BOARD ACTION REPORT – APPEALABLE ITEM

Project Name: Patio Beach Delray
Project Location: 303 Gleason Street
Request: Class III Site Plan Modification
Board: Site Plan Review and Appearance Board (SPRAB)
Meeting Date: March 23, 2016

---STAFF REPORT---

ITEM: **Patio Beach Delray** - Class III Site Plan Modification associated with construction of a 2nd story building addition for four units within an existing one-story 10-unit condominium development.

ARCHITECTURAL SITE
SP.1
SHEET NO.

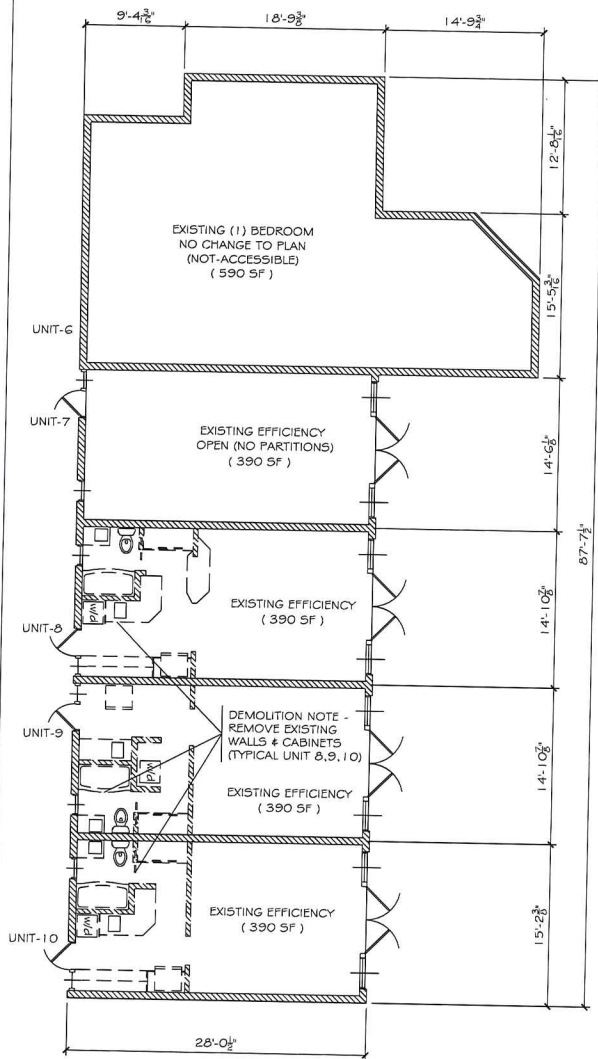
2. Please note that Sheet SP-1 indicates a total of 8 units. This shall be corrected prior to site plan certification.
3. Provide a traffic statement or study. A traffic concurrency determination that either satisfies the requirements of the City of Delray Beach Traffic Engineer or the Palm Beach County Traffic Division is required.

PROPOSED (SOUTH) ELEVATION
1/4" = 1'-0"

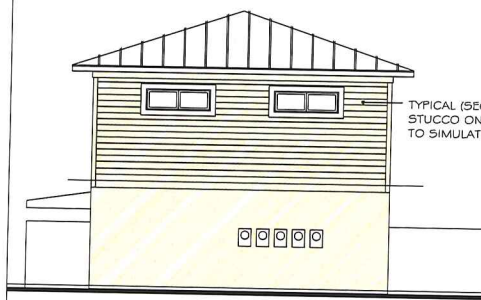
- The south elevation did not demonstrate a visual transition between the upper and lower levels.
- The existing trees to be affected by the required landscape curbing and islands are either durable enough to withstand relocation or already dead and in need of removal. Thus, the upgrades can be accommodated.
- A structural engineer will be required to inspect the existing building to assure that the existing structure can withstand the second story addition. This is required prior to building permit issuance, but not for SPRAB consideration.
- Speculated regarding why only four units instead of all 10 units were being renovated and verified HOA and remaining 6 condominium owners support with staff and applicant.

- **Site Plan** - Staff's recommended 5 conditions, with a slight change to the wording on condition #3 to specify a traffic statement requirement instead of a traffic study.
- **Landscape Plan** – Staff's recommended 5 conditions, as stated in the staff report.
- **Architectural Elevations** – Staff's recommended condition #1 only. The Board removed staff's recommended condition #2 regarding replacement of the blue awning with a color to match the proposed tan and white. The Board added a replacement condition #2 to require the lower level of the affected four units to have stucco finish over the existing painted block. The Board also added a new condition #3 to provide stucco banding to transition the upper level from the lower level on the south elevation.

PROPOSED (WEST) FRONT ELEVATION
1/4" = 1'-0"

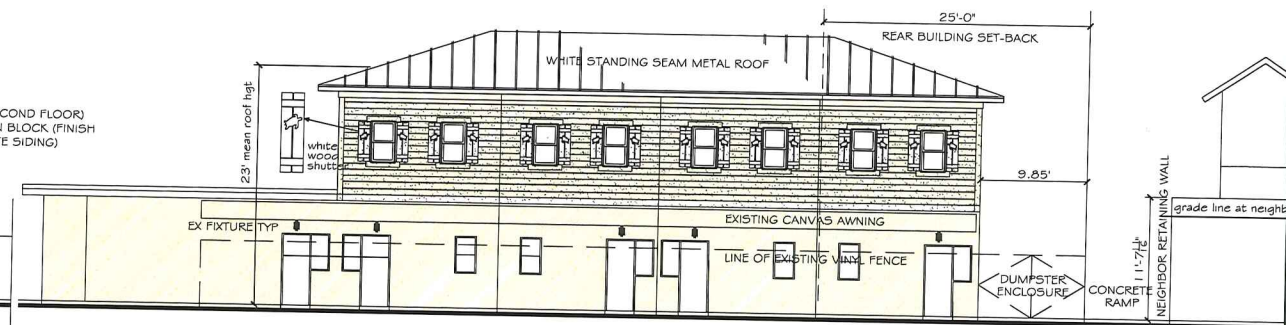
1. There appears to be pattern on the upper level of the proposed west elevation, indicating a material or texture change. However, no change is noted. Either incorporate the pattern in all four elevations or remove it from the west elevation. If retained, notations shall provide clarification of the proposed differentiation in texture or material.
2. Replace the existing blue canvas awning with a color that matches the proposed color scheme (i.e. tan or white).

LANDSCAPE PLAN

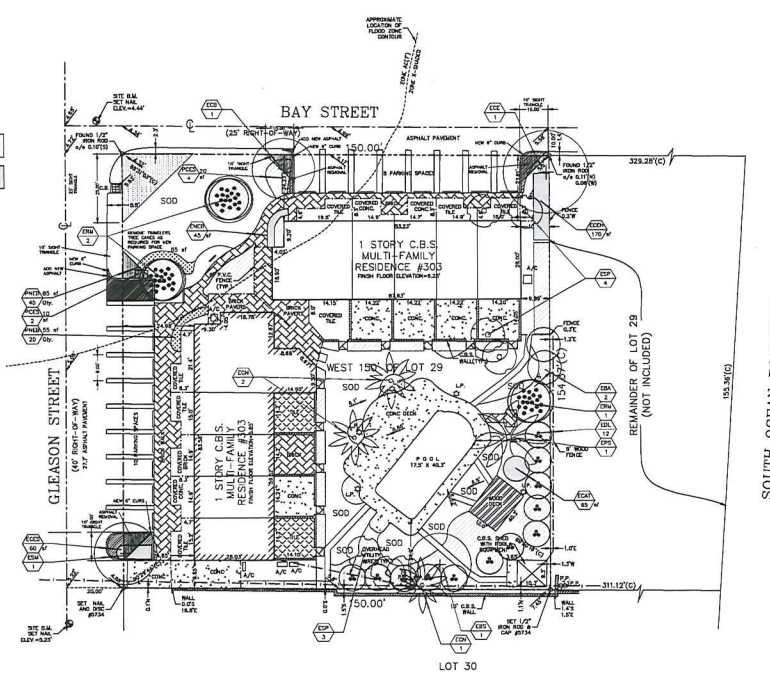
- 2) Per LDR 4.6.16(H)(3)(i), landscape islands are required to have a minimum width of nine feet (9'), exclusive of curbing with a minimum planting area of one hundred and thirty-five square feet (135 SF). Update all applicable plans.

3-14-2016: This comment has NOT been addressed. Per Steve Siebert's letter dated 3/11/2016, he is contesting the requirement to enlarge the islands in an effort to preserve the existing Traveler's Tree at the NW corner of the site. Per Tim's email dated 3/11/2016, he recommends to let SPRAB make the decision on this.
